In-Vehicle Battery Durability

OICA comments on GTR 22
EVE-IWG #57
13.07.2022

Figure 2
Flow chart for Part B : Verification of Battery Durability

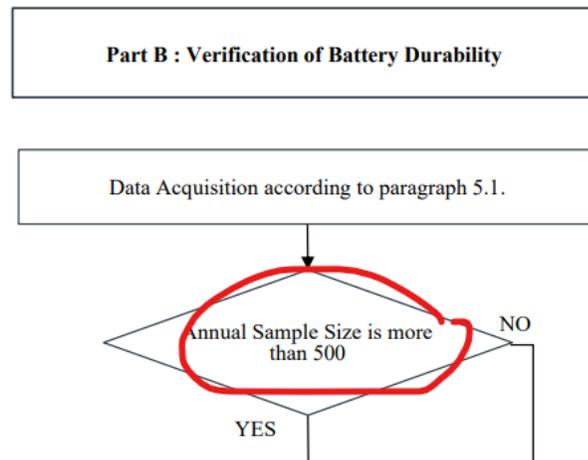
Figure 2 in paragraph 6.5. says:

- Annual sample size is more than 500, ...

→ Figure 2 amended as follows: “Annual sample size is **equal to or more than 500**”
